To: T10 Committee (SCSI)

From: Jim Hafner (IBM) (hafner@almaden.ibm.com)

Subject: Long Identifiers in SPC-3, SAM-2, SBC-2 and other XOR issues

Table xx4. DEVICE/PORT DESIGNATION field format.

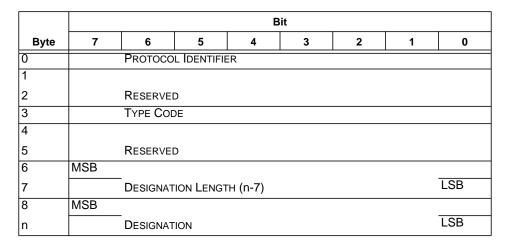
The ALIAS LIST ENTRIES contains a list of alias entries as specified in Table xx3. Each alias entry contains an 8 byte ALIAS value that the device server associates to the value in the DEVICE/PORT DESIGNATION field. The structure of the DEVICE/ PORT DESIGNATION field is described in Table xx4. The number of bytes in each alias entry can be determined from the length field in the DEVICE/PORT DESIGNA-TION field.

The PROTOCOL IDENTIFIER field defines the transport protocol to which the IDENTI-FIER applies; the defined values of the PROTOCOL IDENTIFIER field are defined in Table 165 (of SPC-2 rev 19). The TYPE CODE defines the format of the DESIGNA-TION field with respect to the specific transport protocol as defined in the appropriate protocol standard. The DESIGNATION LENGTH specifies the number of bytes of the DESIGNATION field. This value shall be a multiple of 4. A DESIGNATION value that is not a multiple of 4 bytes long shall be padded in the least significant bytes by zeros to the next largest multiple of 4 bytes long.

The DESIGNATION field should designate a unique SCSI Device or SCSI Port using the following identifying data:

- a) one SCSI Device Name or one SCSI Port Name (required),
- b) one or more optional SCSI Port Addresses or transport-specific addresses.
